Vehicle: All Technical Service Bulletins Oil Pressure Sensor Service (Add Shield or Relocate Sensor)

Bulletin Number: 88-8-22 Reference Number: 738101R

Subject: OIL PRESSURE SENSOR SERVICE (ADD SHIELD OR RELOCATE SENSOR)

Affected: 1985-88 FIERO WITH 2.8L V-6 (VIN CODE 9) AND AIR CONDITIONING

FIGURE 1

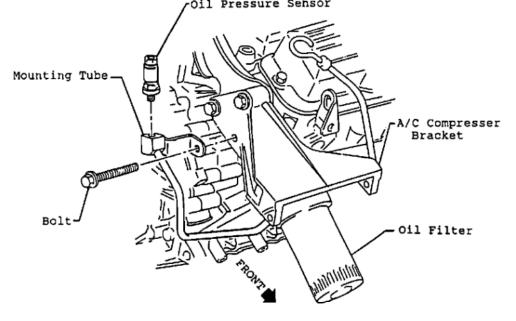
If an oil pressure sensor is replaced on a 1988 model, the sensor should be moved to the oil pump location just above the filter, using the following procedure:

- 4. Remove the oil pressure sensor mounting tube retaining bolt (Figure 1), then move the tube out of the way. Reinstall the bolt, and torque to 50 N-m (37 lb. ft.).
 - Remove the screw from the Electronic Vacuum Regulator Valve (EVRV) mounting bracket, and move the EVRV out of the way.
 - Remove the oil pressure sensor connector wire from the conduit, down to the first tape on the conduit (about 9 inches). Tape the wire to the conduit so that the wires are facing down. Route the oil pressure sensor wires near the main harness, just above the A/C compressor. Reinstall the rest of the wires back into the conduit and retape. Reinstall the main harness retaining clip, insuring that the clip does not touch the transmission cooler lines or pinch any wires.
- 7. Reinstall the EVRV on its mounting bracket.
- 8. Hoist vehicle.
- 9. Remove oil filter.

- 10. Using a back-up wrench on the brass fitting (Figure 2), remove oil pressure sensor mounting tube and discard. Remove the brass fitting and discard it also.
